FED. ROAD DIST. NO.	STATE	FED. AID PROJ. NO.	FISCAL YEAR	SHEET NO.	TOTAL SHEETS
HAWAII	HAW.	STP-0440(5)	1994	13	23

DRAINAGE PLAN

MANELE ROAD RESURFACING
Vicinity of Lanai City towards Manele Bay
Project No. STP-0440(5)

"AS-BUILT"

PROFILE - 30" CSP AT STA. 156+50
Scale: 1" = 10'-0"

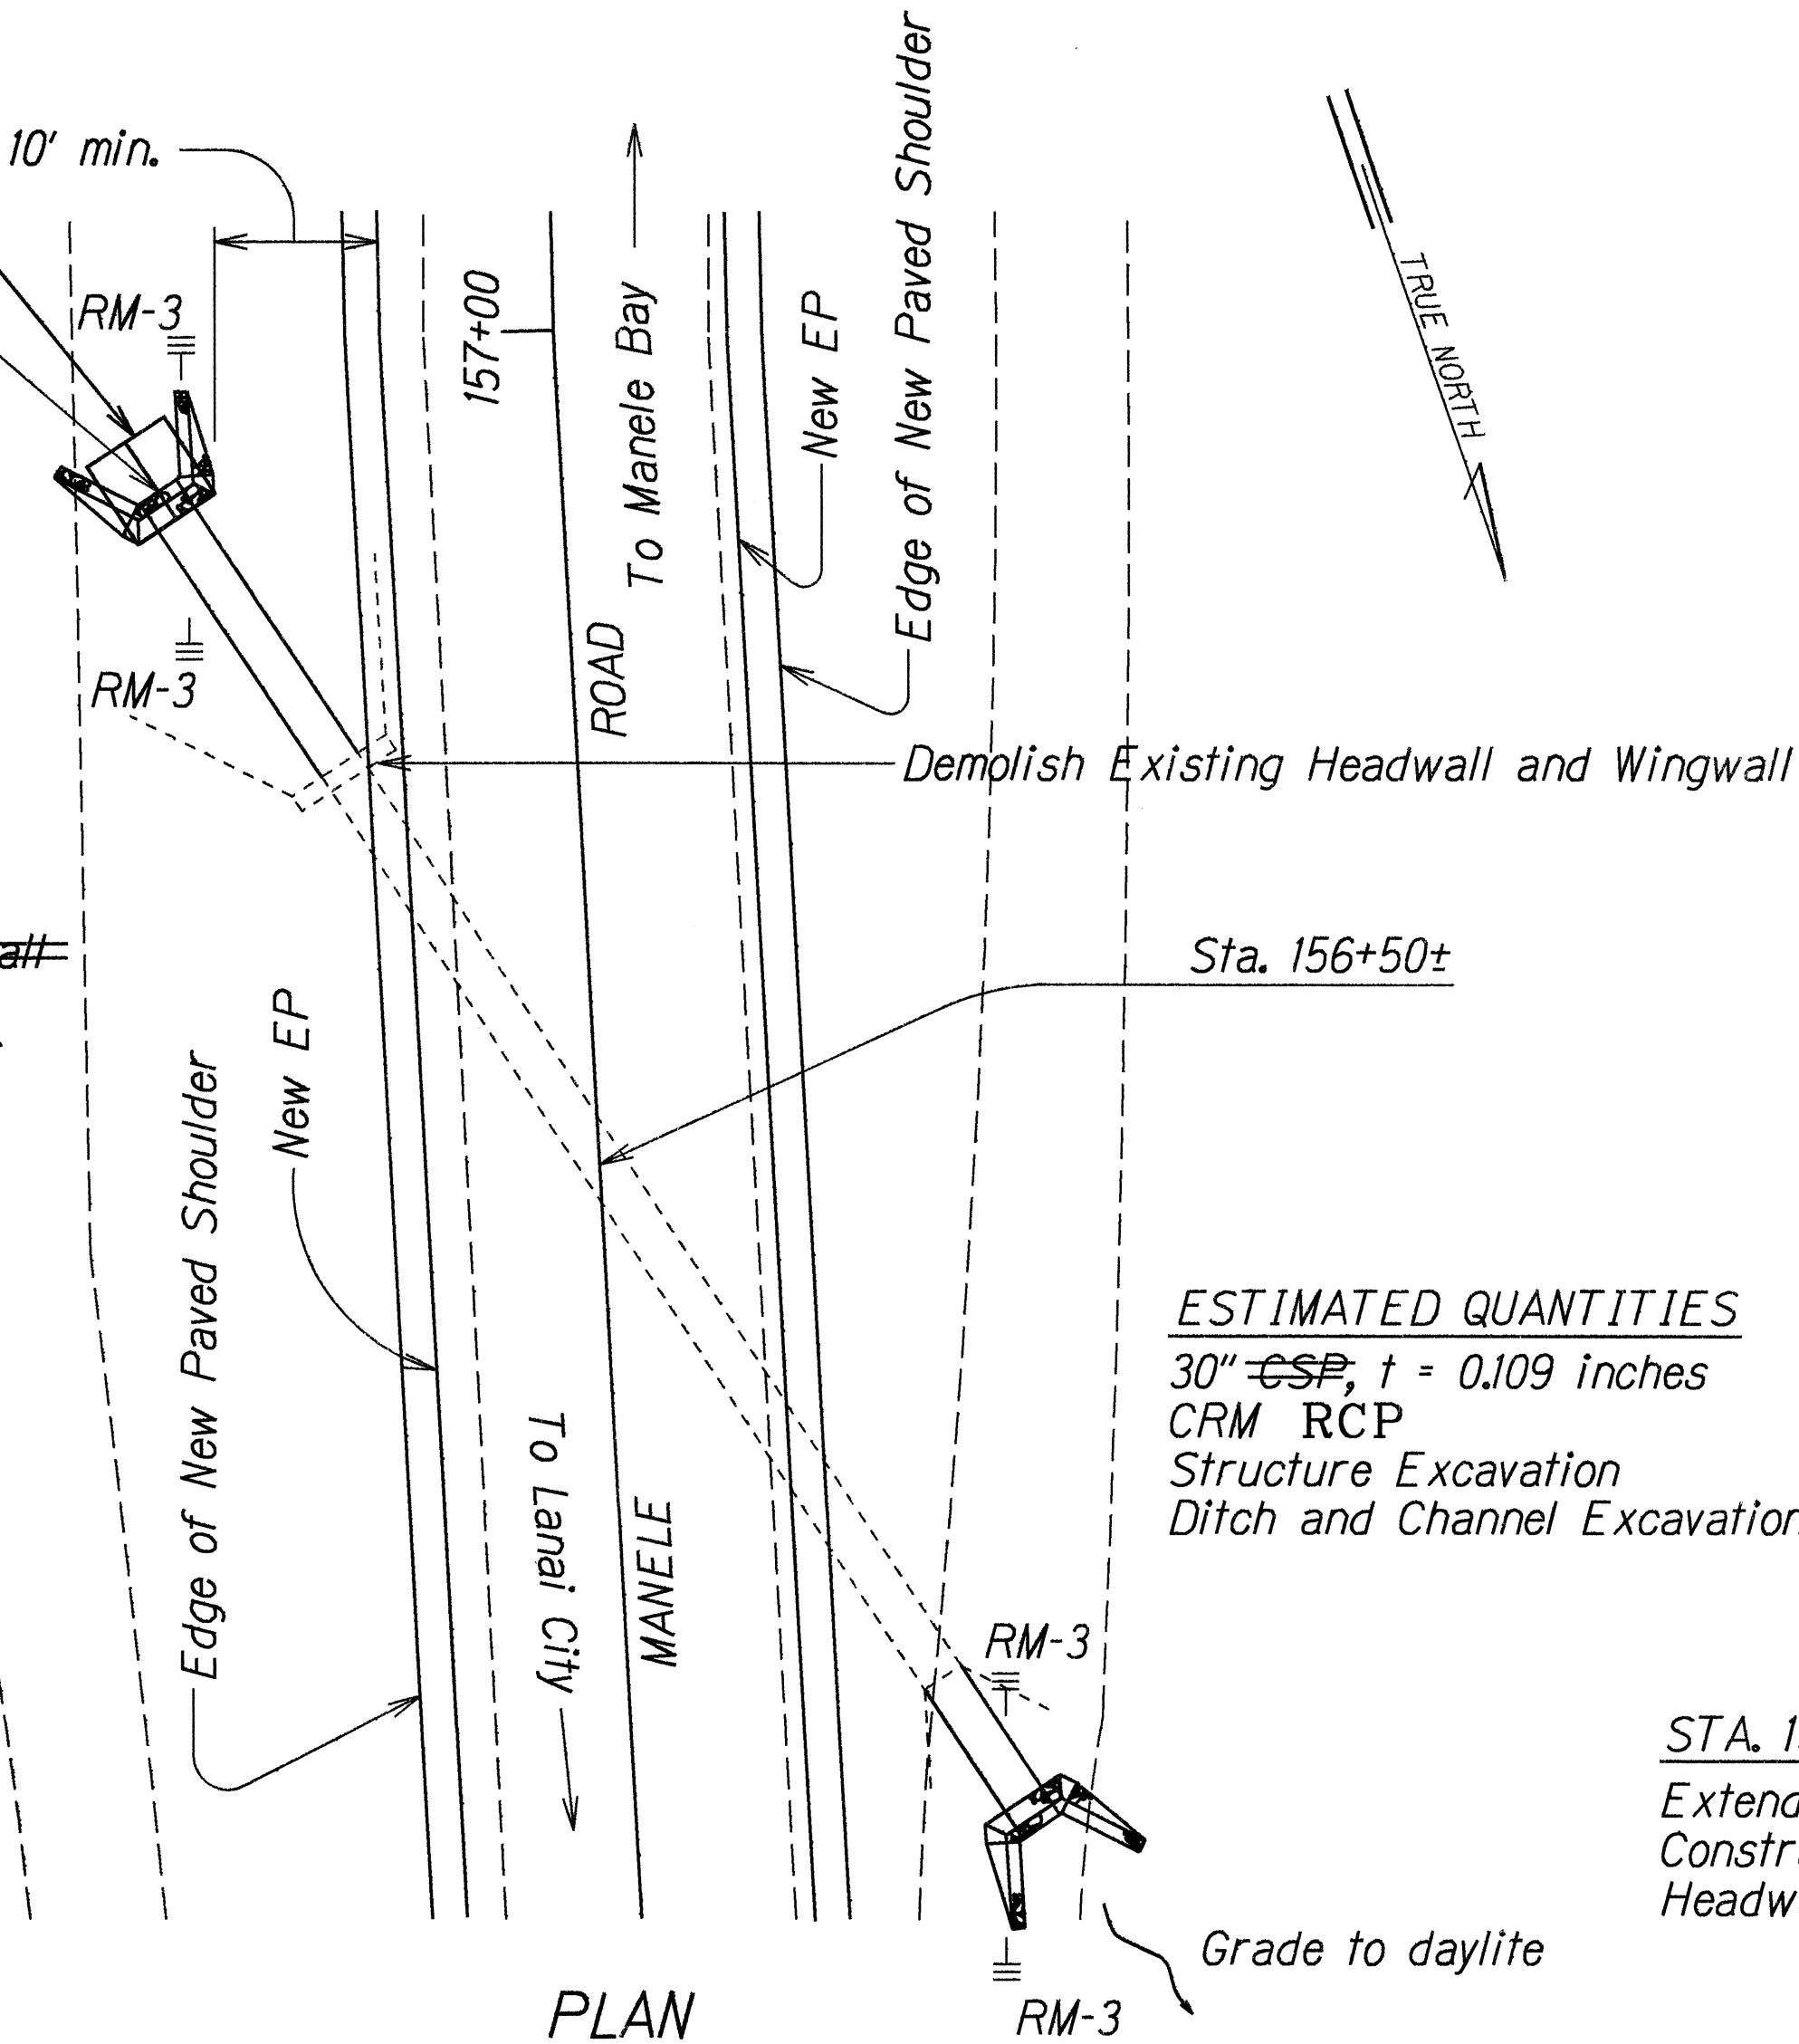
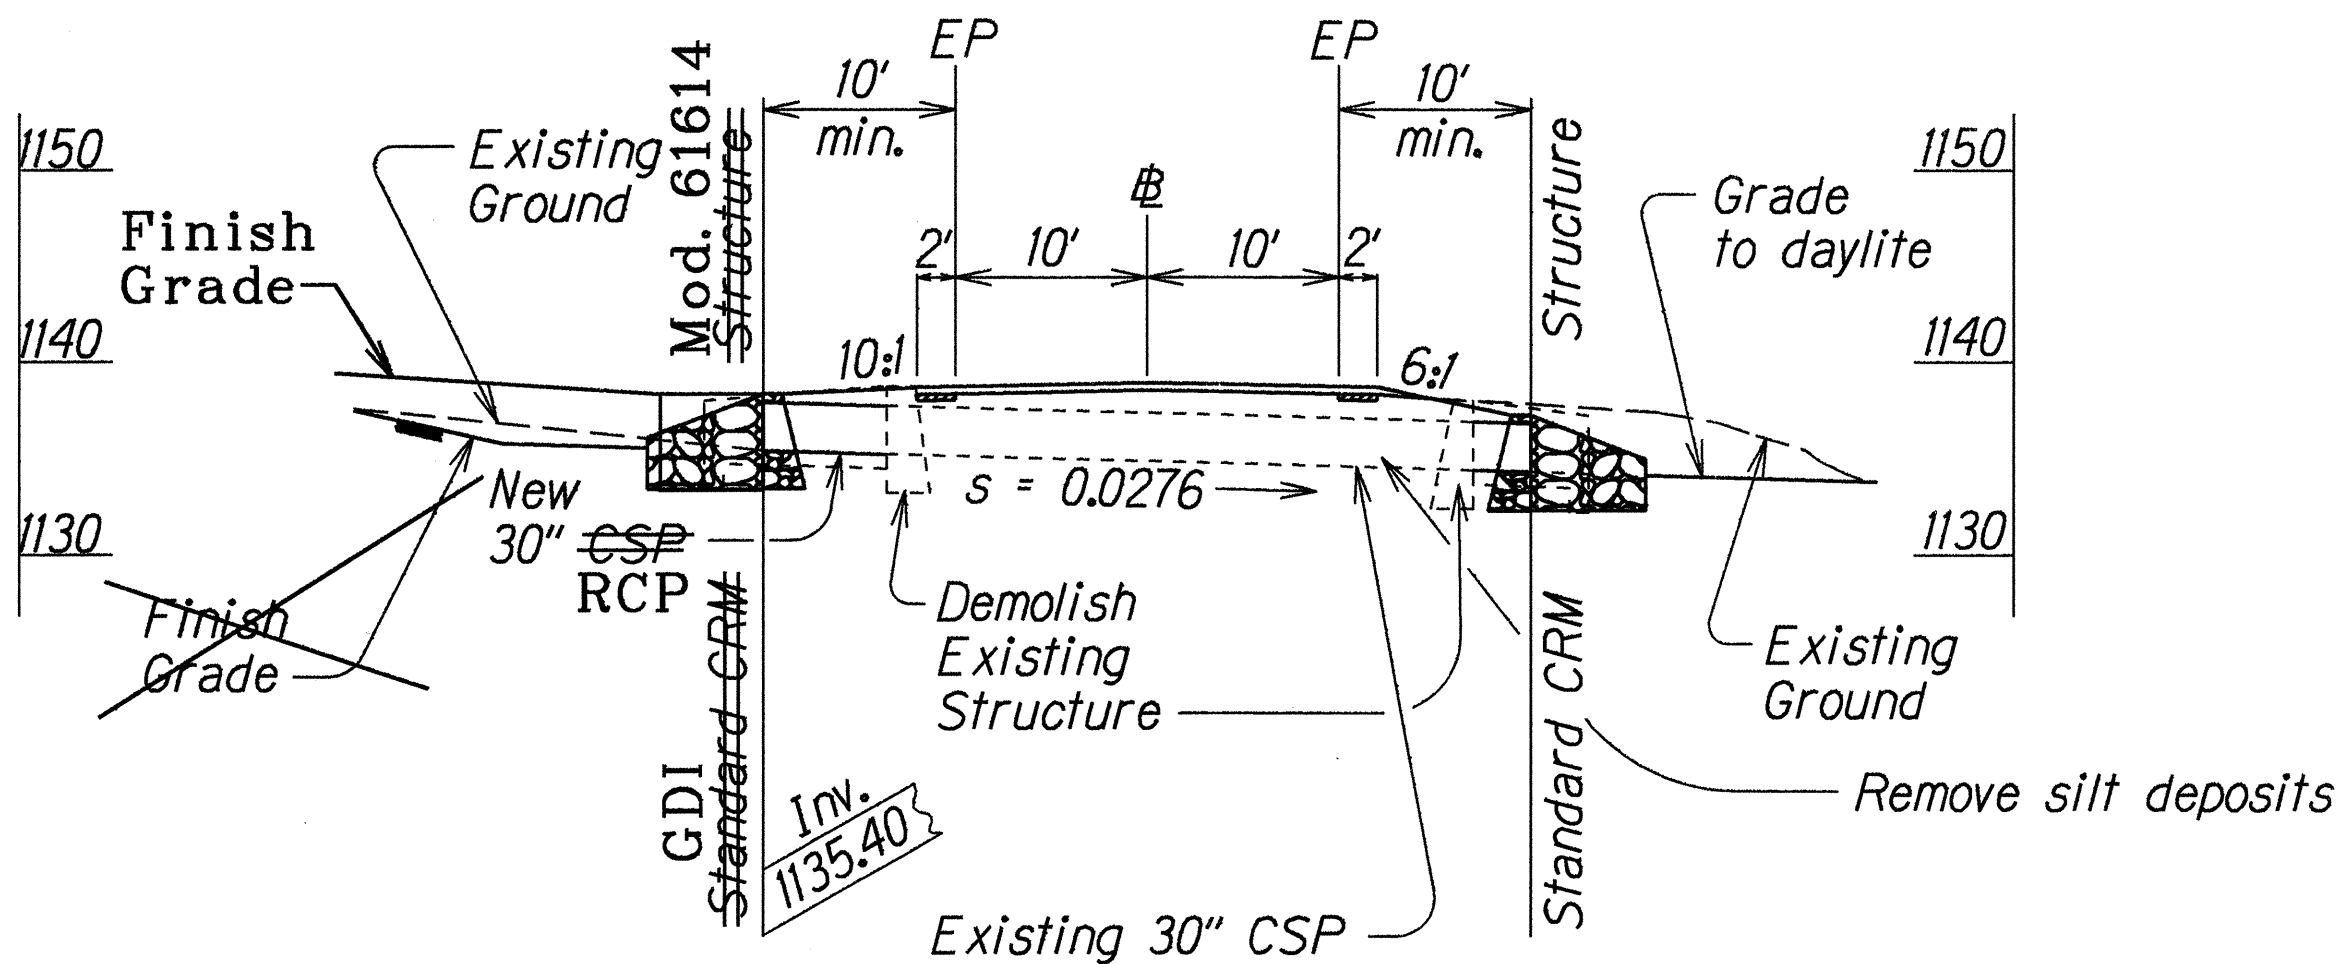
Delete Headwall and Install New GDI, Modified 61614

STA. 156+85± LT.
Extend 30" CSP RCP
Standard CRM Structure
(See Std. Plan H-16)
Inv 1135.4±

STA. 156+85± LT.
~~Construct Standard CRM Headwall and Wingwall~~
Install: 30" CSP, t = 0.109 inches RCP

6/2/94 Install culvert @ outlet Sta. 156+50 per Addendum No. 1
